No. 5:20-cv-06249-JMG

**CONSENT ORDER BETWEEN PLAINTIFF UNITED STATES AND THE VIEWS AT
PINE VALLEY I, LP**

CEDAR VIEWS APARTMENTS – RETROFIT PLAN

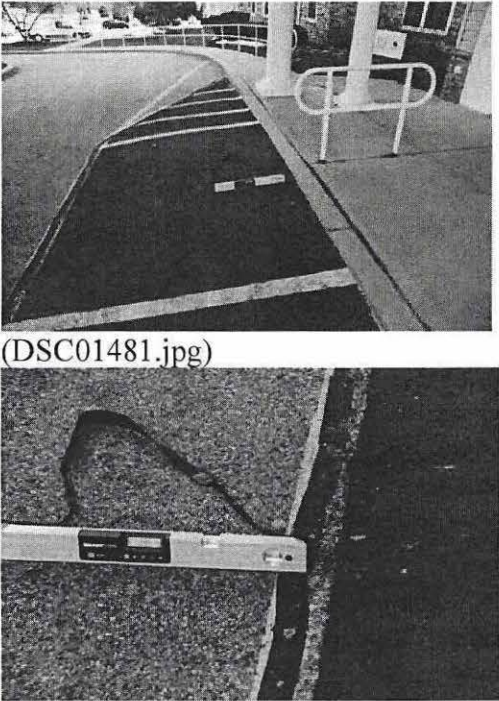
Inaccessible Feature	Photograph(s)	Retrofit(s)
A.2.	<p>The proposed accessible route crosses the vehicular drive heading northeast to the public right of way. The middle section of this crossing has cross slopes that range between 3.4% and 4.3% (see line 23 of the Accessibility Report).</p> <p>Accessible route cannot have a cross slope that is more than 2%.</p> <p>(FHA Guidelines, Req. 1 or 2, 4.3.7; ADA 206.2.1; 403.3)</p>	 <p>(DSC01643.jpg)</p>  <p>(DSC01646.jpg)</p>	<p>Scarify and resurface asphalt paving at crossing.</p>

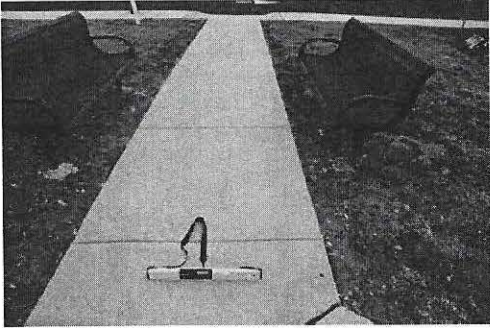
Inaccessible Feature	Photograph(s)	Retrofit(s)
<p>A.3. There is a vertical change of about 3/4" at a joint in the sidewalk (see line 26 of the Accessibility Report).</p> <p>Abrupt changes in level cannot exceed 1/2".</p> <p>(FHA Guidelines, Req. 1 Req. 2, 4.3.8; ADA 206.2.1; 303.2)</p>	 <p>(DSC01660.jpg)</p>  <p>(DSC01661.jpg)</p>	<p>Grind existing concrete paving to bevel the raised edge at 1:12, or replace concrete.</p>

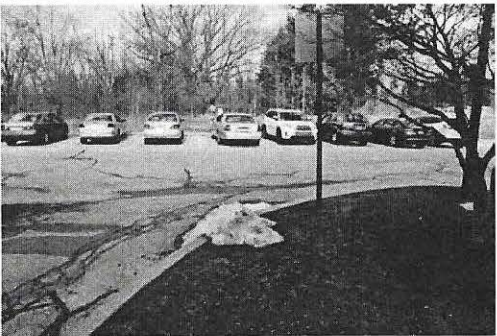
Inaccessible Feature	Photograph(s)	Retrofit(s)
<p>A.4. To the right (north) of the curb ramp at the accessible parking north of the East Entrance, extending for about 10 feet, the cross slope is 6.6% to 7.1% (see line 27 of the Accessibility Report).</p> <p>Accessible route cannot have a cross slope that is more than 2%.</p> <p>(FHA Guidelines, Req. 1 or 2, 4.3.7; ADA 206.2.1; 403.3)</p>	 <p>(DSC01662.jpg)</p>  <p>(DSC01663.jpg)</p>  <p>(DSC01665.jpg)</p>	<p>Remove and replace sidewalk.</p>

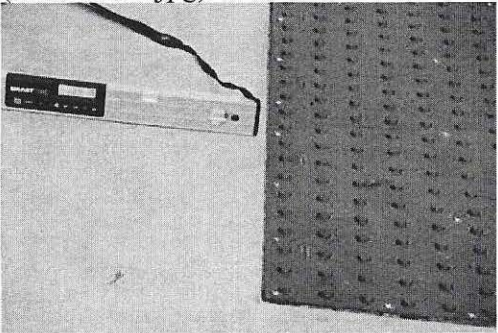
Inaccessible Feature	Photograph(s)	Retrofit(s)
A.5.	<p>Sidewalk at northeast corner of the grounds terminates at a vertical curb. (Route is shown on Accessible Route Diagram; vertical curb not included in Accessibility Report).</p> <p>A continuous accessible route to the public right-of-way is required.</p> <p>(FHA Guidelines, Req. 1 or 2, 4.3.7; ADA 206.2.1; 303.2)</p>	 <p>(DSC01637.jpg)</p>	Install curb ramp.
A.6.	<p>Route from northeast corner of the grounds to the sidewalk leading to Ernest Way crosses the vehicular drive at a diagonal. (Route shown on Accessible Route Diagram; marking for crosswalk not included in Accessibility Report).</p>	 <p>(DSC01641.jpg)</p>	Stripe crossing. Verify cross slopes are maximum 2% at route.

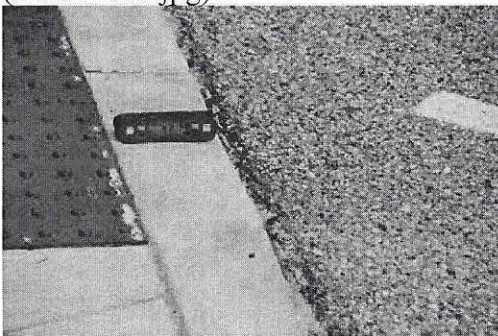
Inaccessible Feature	Photograph(s)	Retrofit(s)
A.7.	<p>Beginning about 15' south of the curb ramp at the northeast accessible parking area, continuing about 10' towards the East Entrance, the cross slope is 3.8%. (Route is shown on Accessible Route Diagram; cross slope not included in Accessibility Report).</p> <p>The accessible route cannot have a cross slope that is more than 2%.</p> <p>(FHA Guidelines, Req. 1 or 2, 4.3.7; ADA 206.2.1; 403.3)</p>	 <p>(DSC01625.jpg)</p>  <p>(DSC01626.jpg)</p>	Remove and replace sidewalk.

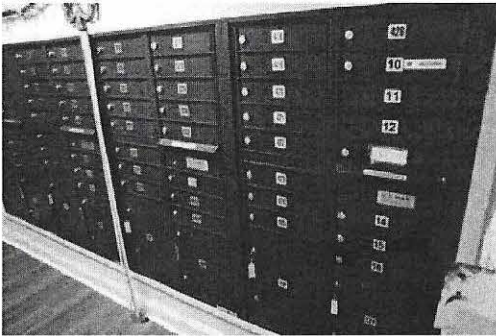
Inaccessible Feature	Photograph(s)	Retrofit(s)
<p>A.11. The accessible route turns on the curb ramp at the East Entrance. Therefore, the curb ramp creates a cross slope of 10.4%.</p> <p>Accessible route cannot have a cross slope that is more than 2%. Where the accessible route turns, the cross slope is measured in two directions.</p> <p>(FHA Guidelines, Req. 1 or 2, 4.3.7; ADA 206.2.1; 403.3)</p>	 <p>(DSC01618.jpg)</p>  <p>(DSC01620.jpg)</p>	<p>Remove and replace concrete walkway and curb ramp with no cross slopes exceeding 2%.</p>

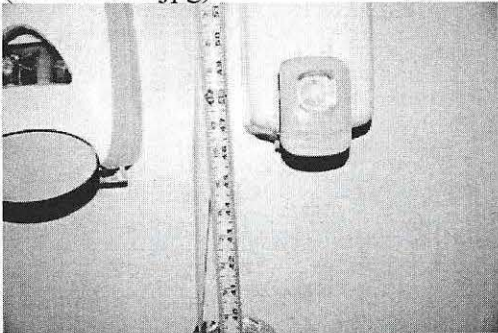
Inaccessible Feature	Photograph(s)	Retrofit(s)
<p>B.3. The controls of the top two rows of mailboxes in the first floor mail room are 57 3/4" and 61" above the floor.</p> <p>The operable parts for the mailboxes may not be mounted any higher than 54".</p> <p>(FHA Guidelines Req. 2, 4.25.3)</p>	 <p>(DSC01460.jpg)</p>  <p>(DSC01464.jpg)</p>	<p>Subject to approval by the U.S. Postal Service, add accessible mailboxes in another location in the lobby as necessary to replace boxes located at the top two existing rows and install blank plates at top two rows of existing frames.</p>

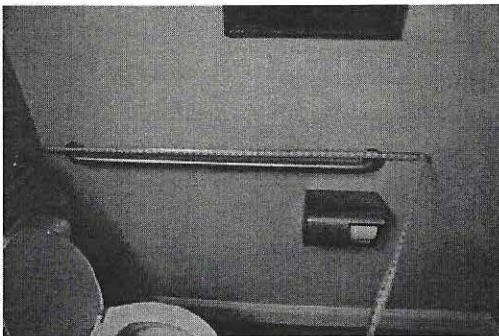
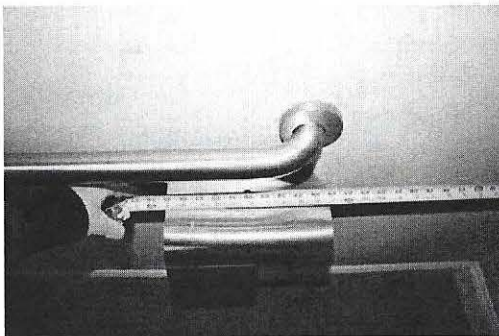
Inaccessible Feature	Photograph(s)	Retrofit(s)
First Floor Restroom		
<p>B.4. The maneuvering space beside the latch side of the door to the first floor restroom extends 4".</p> <p>The pull side of the door requires a forward approach. Therefore, the maneuvering space must be 60" deep and must extend 18" to the side of the latch.</p> <p>(ADA Standards 4.1.3(7)&(8), 4.13.6, FHA Guidelines Req. 2, 4.13.6)</p>	 <p>(DSC01423.jpg)</p> <p>(DSC01427.jpg)</p>	<p>Reverse direction of door swing to allow for required maneuvering space.</p>

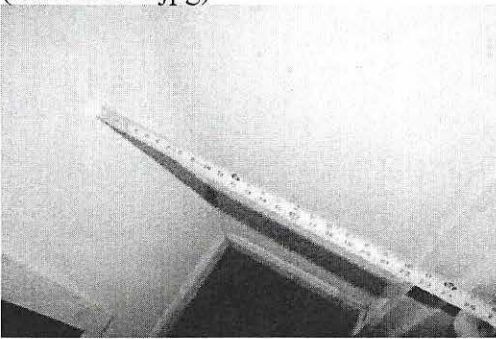
Inaccessible Feature	Photograph(s)	Retrofit(s)
B.5.	<p>The door to the first floor restroom has a closer and the maneuvering space extends 3 3/4" to the latch side.</p> <p>A forward approach to the push side of the door is required. The door has a latch. If it has a closer, then, the maneuvering space must extend 12" to the latch side of the door.</p> <p>(ADA Standards 4.1.3(7)&(8), 4.13.6, FHA Guidelines Req. 2, 4.13.6)</p>	 <p>(DSC01431.jpg)</p>  <p>(DSC01456.jpg)</p>	Reverse direction of door swing to allow for required maneuvering space.

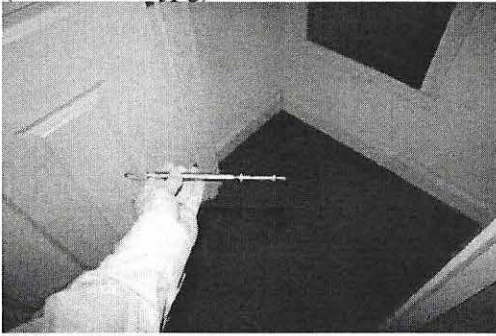
Inaccessible Feature	Photograph(s)	Retrofit(s)
B.7.	<p>The top of the wall-hung lavatory in the first floor restroom is 35" above the floor.</p> <p>Top of the lavatory and counter cannot be higher than 34".</p> <p>(ADA Standards 4.1.3(11), 4.19.2, FHA Guidelines Req. 2, 4.19.2.2)</p>	 <p>(DSC01441.jpg)</p>  <p>(DSC01442.jpg)</p>	<p>Lower lavatory so that the top is no higher than 34".</p>

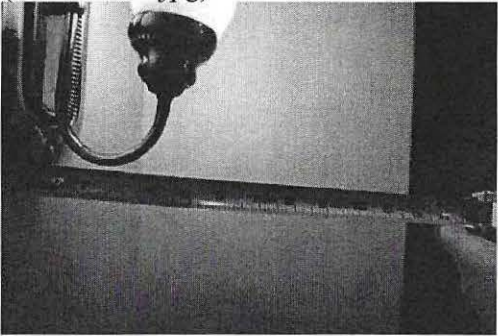
Inaccessible Feature	Photograph(s)	Retrofit(s)
B.8.	<p>The soap and hand sanitizer dispensers in the first floor restroom reduce the clear space above the rear grab bar to about 11".</p> <p>There must be at least 12" of clear space above the grab bar.</p> <p>(ADA Standards 4.1.3(11), 4.26.2, FHA Guidelines Req. 2, 4.24.2)</p>	 <p>(DSC01443.jpg)</p>  <p>(DSC01445.jpg)</p>	<p>Relocate the soap and hand sanitizer dispensers to allow required clear space above the rear grab bar.</p>

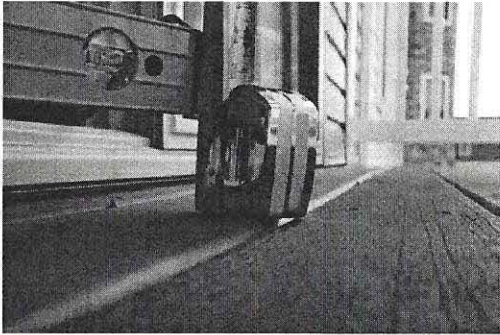
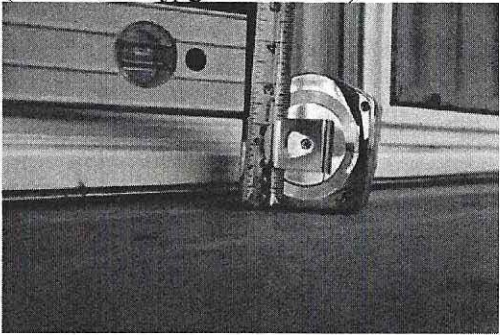
Inaccessible Feature	Photograph(s)	Retrofit(s)
B.12.	<p>The corridor doors to the trash chutes require 11 pounds force.</p> <p>Common use interior doors must be openable with no more than 5 pounds force. Fire doors must be openable with the minimum opening force permitted by the local building/fire official.</p> <p>(FHA Guidelines Req. 2, 4.13.11)</p>	 <p>(DSC00960.jpg)</p>	<p>Replace door closers with delay-action closers that require no more than 5 pounds force.</p>

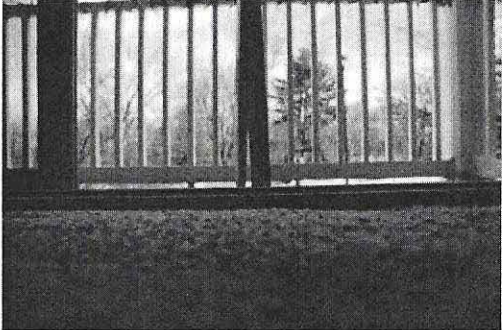
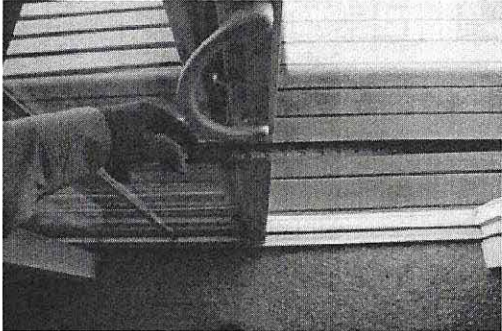
Inaccessible Feature	Photograph(s)	Retrofit(s)
<p data-bbox="153 272 821 375">B.13. In the trash rooms, the control on the trash chute intake door requires 10 to 11 pounds force.</p> <p data-bbox="270 418 816 521">The control for the trash chute intake door must be openable with no more than 5 pounds force.</p> <p data-bbox="270 565 695 597">(FHA Guidelines Req. 2, 4.25.4)</p>	 <p data-bbox="846 605 1056 638">(DSC00958.jpg)</p>  <p data-bbox="846 971 1056 1003">(DSC00959.jpg)</p>	<p data-bbox="1417 272 1955 375">If feasible, adjust the chute intake doors to reduce the amount of force required for operation.</p>

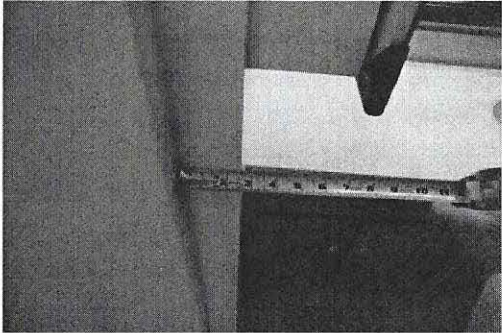
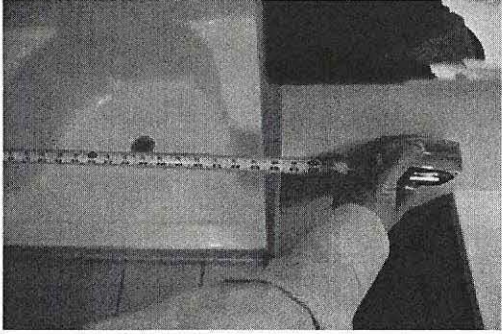
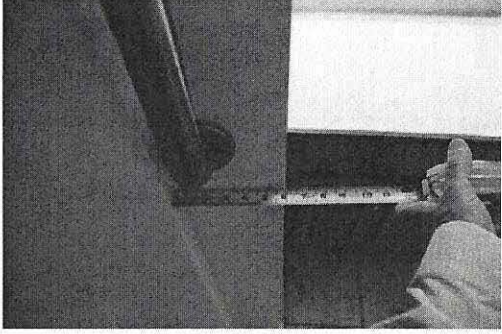
Inaccessible Feature	Photograph(s)	Retrofit(s)
Hallways		
<p>B.14. The undersides of the hallway light sconces are 64" above the landing and protrude 6" into the accessible route.</p> <p>Objects may not protrude into the circulation path by more than 4" if the underside is more than 27" but less than 80" above the floor.</p> <p>(FHA Guidelines Req. 2, 4.4.1)</p>	 <p>(DSC00724.jpg)</p>  <p>(DSC00725.jpg)</p>	<p>Remove existing light fixtures and replace with fixtures that protrude no more than 4" into the circulation path.</p>

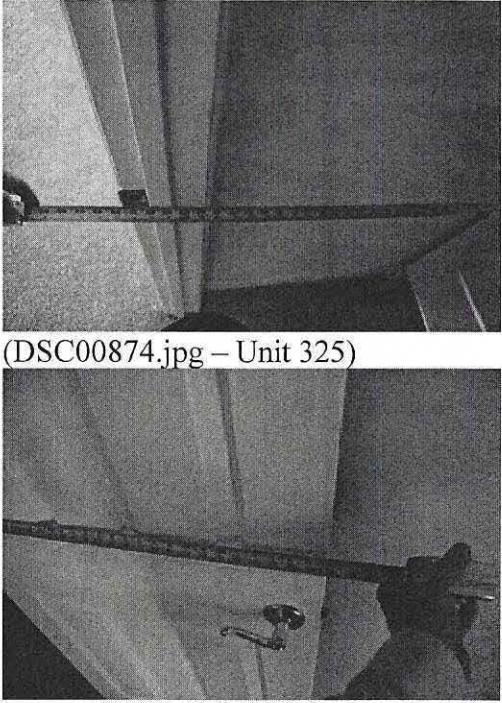
Inaccessible Feature	Photograph(s)	Retrofit(s)
<p>C.2. At upper level units with pervious decks, the tops of the balcony thresholds are more than 1 1/4" above the balcony.</p> <p>A balcony or terrace with a pervious surface, such as wood or pavers on pedestals, cannot be more than 1/2" below the interior finish floor. The top of the threshold cannot be more than 1 1/4" above the terrace.</p> <p>(FHA Guidelines Req. 4(5))</p>	 <p>(DSC00880.jpg – Unit 325)</p>  <p>(DSC00928.jpg – Unit 328)</p>	<p>Purchase and keep on hand in the management office, a minimum of 2 ramps suitable for installation at 1 1/2", 2", and 2 1/2" high thresholds (total of 6).</p> <p>Post a laminated notice inside the kitchen sink base notifying residents that ramps are available to residents on request. Submit product and wording for notice to DOJ for review and approval prior to purchasing products and printing notices.</p>

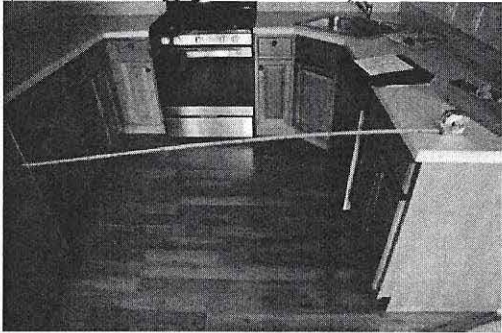
Inaccessible Feature	Photograph(s)	Retrofit(s)
<p>C.3. At units at grade (with concrete patios), the surfaces of the patios are more than 4 3/4" below the top of the threshold.</p> <p>In the dwelling unit, the impervious balcony surface may be up to 4" below the finish floor and 4 3/4" below the top of the threshold.</p> <p>(FHA Guidelines Req. 4(4))</p>	 <p>(DSC01168.jpg – Unit 124)</p>	<p>Post a laminated notice inside the kitchen sink base notifying residents that property management will provide a raised deck surface with pervious decking on request. Submit wording for notice to DOJ for review and approval prior to purchasing products and printing notices.</p> <p>Raised deck to match the size and shape of the existing patio surface and be set no more than 1/2" lower than the interior floor.</p> <p>(Note: This issue does not apply to Unit 326.)</p>
<p>C.4. Balcony and patio doors clear openings widths are less than 31 5/8".</p> <p>The sliding door clear opening must be at least a nominal 32" (31 5/8").</p> <p>(FHA Guidelines Req. 3(2))</p>	 <p>(DSC00879.jpg – Unit 325)</p>	<p>No retrofit required for sliding doors with clear openings of at least 31".</p> <p>For sliding doors with clear openings of less than 31", adjust or modify door stop to widen opening to a minimum width of 31 1/2".</p>

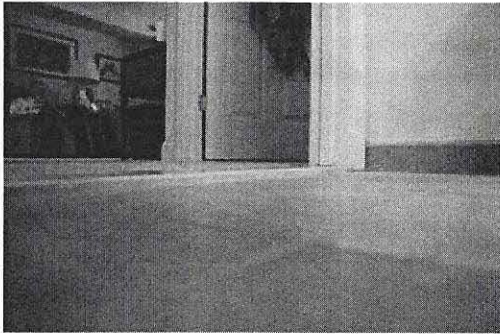
Inaccessible Feature	Photograph(s)	Retrofit(s)
D. Dwelling Units Unit Type Specific Retrofits		
Type A – 2 Bedroom, 2 Bath (28 Units of this Type) (Surveyed Units: 325 and 328)		
<p>D.1. The smaller bedroom walk-in closet is 47" deep and the clear opening is 27 1/2".</p> <p>If the closet is deeper than 24", the closet door is intended for user passage. It must provide at least 31 5/8" clear opening.</p> <p>(FHA Guidelines Req. 3(2))</p>	 <p>(DSC00874.jpg – Unit 325)</p> <p>(DSC00872.jpg – Unit 325)</p>	<p>If feasible (i.e., where the closet is at least 36" wide) remove door and install cased opening to provide at least 31 5/8" clear opening.</p> <p>If not feasible, post laminated notice in the closet notifying the resident that closet fittings (shelves and hanging rod/bar) can be relocated or depth of closet reduced to 24" on request of the resident. Submit wording for notice to DOJ for review prior to printing notice.</p>

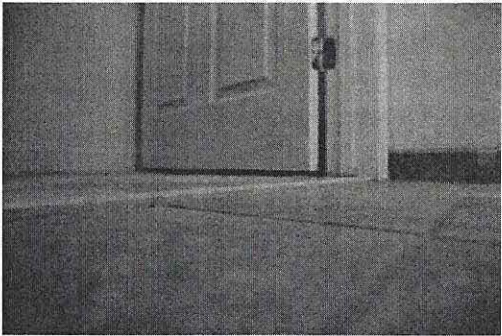
Inaccessible Feature	Photograph(s)	Retrofit(s)
Type B – 1 Bedroom, 1 Bath (2 Units of this Type) (Surveyed Units: 419 and 421)		
<p>D.3. The coat closet is more than 24" deep and the clear opening is 21 1/2".</p> <p>If the closet is deeper than 24", the closet door is intended for user passage. It must provide at least 31 5/8" clear opening.</p> <p>(FHA Guidelines Req. 3(2))</p>	<p>No photos taken.</p>	<p>If feasible (i.e., where the closet is at least 36" wide) remove door and install cased opening to provide at least 31 5/8" clear opening.</p> <p>If not feasible, post laminated notice in the closet notifying the resident that closet fittings (shelves and hanging rod/bar) can be relocated or depth of closet reduced to 24" on request of the resident. Submit wording for notice to DOJ for review prior to printing notice.</p>

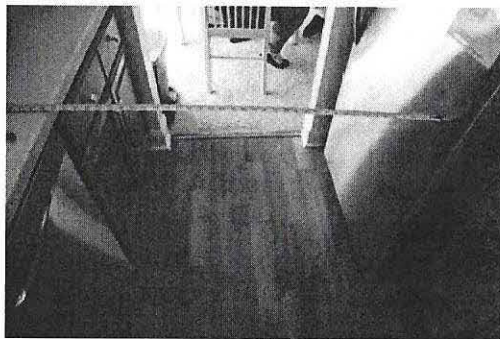
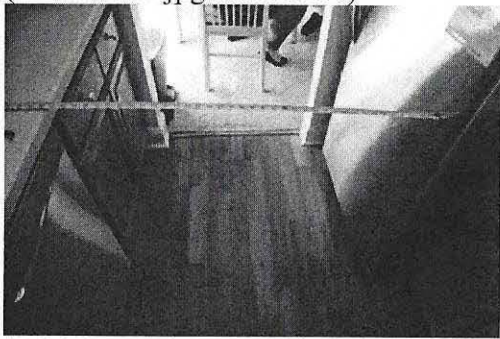
Inaccessible Feature	Photograph(s)	Retrofit(s)
<p>D.4. The U-shaped kitchen in Unit 419 is about 44" wide at the refrigerator and 52 1/2" in front of the range. Similarly, the U-shaped kitchen in Unit 421 is about 46" wide at the refrigerator and 52 1/2" in front of the range. Therefore, a 60" turning circle does not fit in either unit.</p> <p>There is a kitchen sink in the base of the U-shaped kitchen. It requires a parallel clear floor space. Therefore, the kitchen must accommodate a 60"-diameter turning circle.</p> <p>(FHA Guidelines Req. 7(1)(b))</p>	 <p>(DSC01255.jpg – Unit 419)</p> <p>(DSC01257.jpg – Unit 419)</p>	<p>Design the reconfiguration of the kitchen to provide a compliant forward approach to the sink with removable cabinet and submit the design to DOJ for approval. Renovate the kitchens consistent with the approved design, including necessary repair or replacement of finishes, flooring, and counter supports.</p>

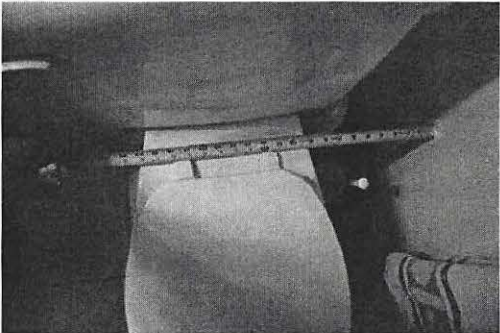
Inaccessible Feature	Photograph(s)	Retrofit(s)
D.5.	<p>The kitchen sink is located in a corner and has a base cabinet. The parallel clear floor space is about 16 1/2" wide.</p> <p>Clear floor space at the kitchen sink must be at least 30" by 48" and centered.</p> <p>(FHA Guidelines Req. 7(1)(a))</p>	 <p>(DSC01259.jpg – Unit 419)</p>	<p>Design the reconfiguration of the kitchen to provide a compliant parallel or forward approach and submit the design to DOJ for review and approval. Include removable sink base if forward approach is used. Renovate the kitchens consistent with the approved design, including necessary repair or replacement of finishes, flooring, and counter supports.</p>
D.6.	<p>The threshold to the bathroom is about 1/2" tall and is not beveled 1:2 on the bathroom side.</p> <p>The dwelling unit entrance is in an interior corridor. The threshold cannot be taller than 1/2". Where the top of the threshold is more than 1/4" above the landing, the transition must be beveled at least 1:2.</p> <p>(FHA Guidelines Req. 4(4))</p> <p>(Note: This issue was observed in Unit 421 but not in Unit 419.)</p>	 <p>(DSC01274 – Unit 421)</p>	<p>Modify or replace threshold so that it is no taller than 1/2" and, if necessary, beveled at least 1:2 with a vertical edge that is no taller than 1/4".</p>

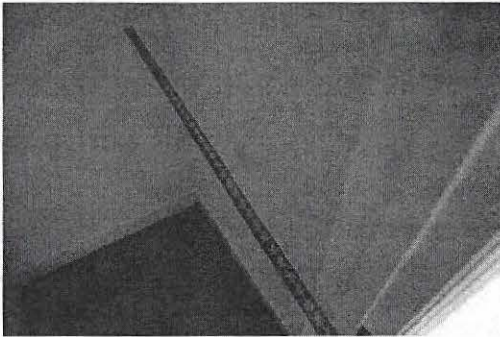
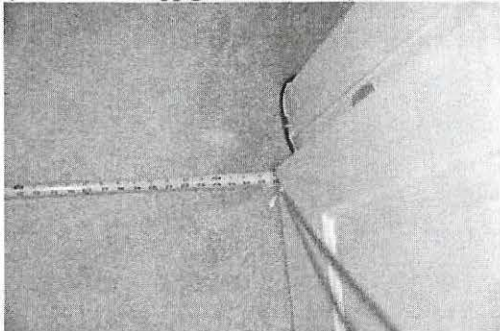
Inaccessible Feature	Photograph(s)	Retrofit(s)
Type B – 2 Bedroom, 1.5 Bath (8 Units of this Type) (Surveyed Units: 214 and 230)		
<p>D.8. The smaller bedroom walk-in closet is 36" deep and the clear opening is 27 1/2".</p> <p>If the closet is deeper than 24", the closet door is intended for user passage. It must provide at least 31 5/8" clear opening.</p> <p>(FHA Guidelines Req. 3(2))</p>	 <p>(DSC01348.jpg – Unit 214)</p>  <p>(DSC01185.jpg – Unit 230)</p>	<p>If feasible (i.e., where the closet is at least 36" wide) remove door and install cased opening to provide at least 31 5/8" clear opening.</p> <p>If not feasible, post laminated notice in the closet notifying the resident that closet fittings (shelves and hanging rod/bar) can be relocated or depth of closet reduced to 24" on request of the resident. Submit wording for notice to DOJ for review prior to printing notice.</p>

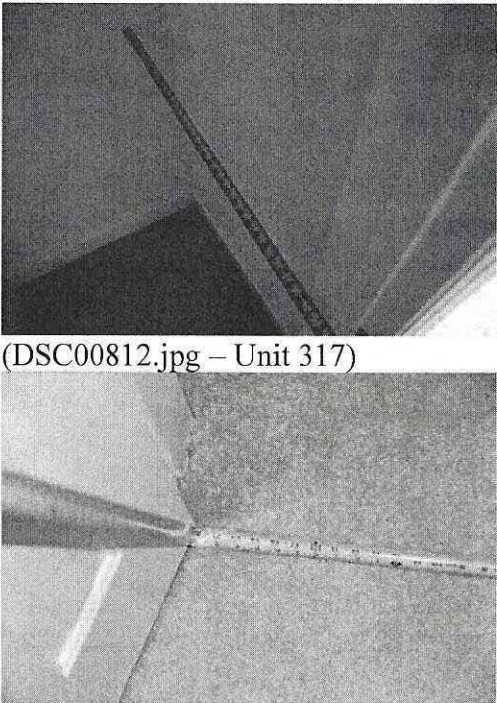
Inaccessible Feature	Photograph(s)	Retrofit(s)
D.9.	<p>At the powder room door, the top of the threshold is 1/2". It is not beveled.</p> <p>The dwelling unit entrance is in an interior corridor. The threshold cannot be taller than 1/2". Where the top of the threshold is more than 1/4" above the landing, the transition must be beveled at least 1:2.</p> <p>(FHA Guidelines Req. 4(4))</p> <p>(Note: This issue was observed in Unit 214 but not in Unit 230.)</p>	 <p>(DSC01342.jpg – Unit 214)</p>	<p>Modify or replace threshold so that it is no taller than 1/2" and, if necessary, beveled at least 1:2 with a vertical edge that is no taller than 1/4".</p>

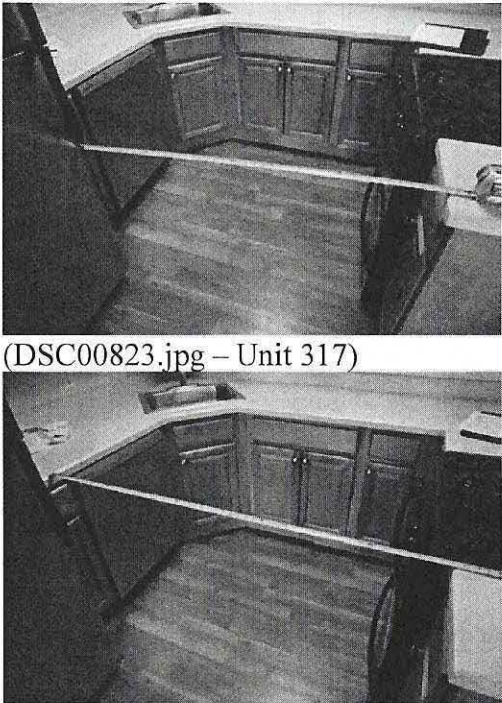
Inaccessible Feature	Photograph(s)	Retrofit(s)
D.10.	<p>The clearance between the refrigerator and the counter is 37 1/2" in Unit 214 and 36 3/4" in Unit 230.</p> <p>Clearance between opposing counters, cabinets, appliances, and walls must be at least 40".</p> <p>(FHA Guidelines Req. 7(1)(b))</p>	 <p>(DSC01349.jpg – Unit 214)</p>  <p>(DSC01181.jpg – Unit 230)</p>	<p>Upon request, replace refrigerator with counter-depth unit that provides at least 40" clearance.</p> <p>Post permanent notice in the sink base cabinet notifying residents that a counter-depth unit is available on request. Notice may include information concerning the difference in cubic feet of storage space between the existing refrigerator and the one which will be provided. Submit wording for notice to DOJ for review and approval prior to and printing notice.</p>

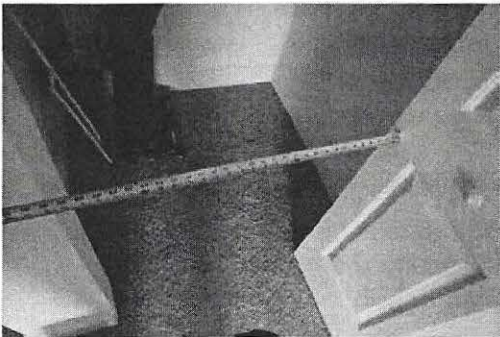
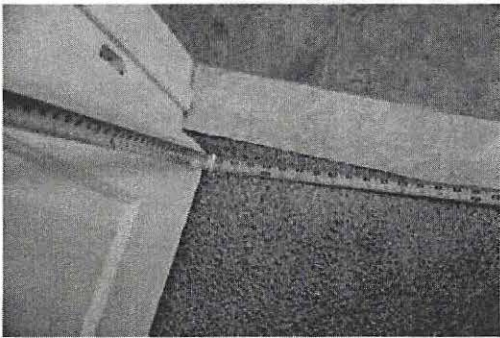
Inaccessible Feature	Photograph(s)	Retrofit(s)
			<p>Exception 2: notify DOJ prior to retrofitting toilet if there are unforeseen conditions affecting the relocation of the fixture. For example, if relocation of the toilet reduces near side clear space to less than 14", retrofit clearances may need to be adjusted.</p>
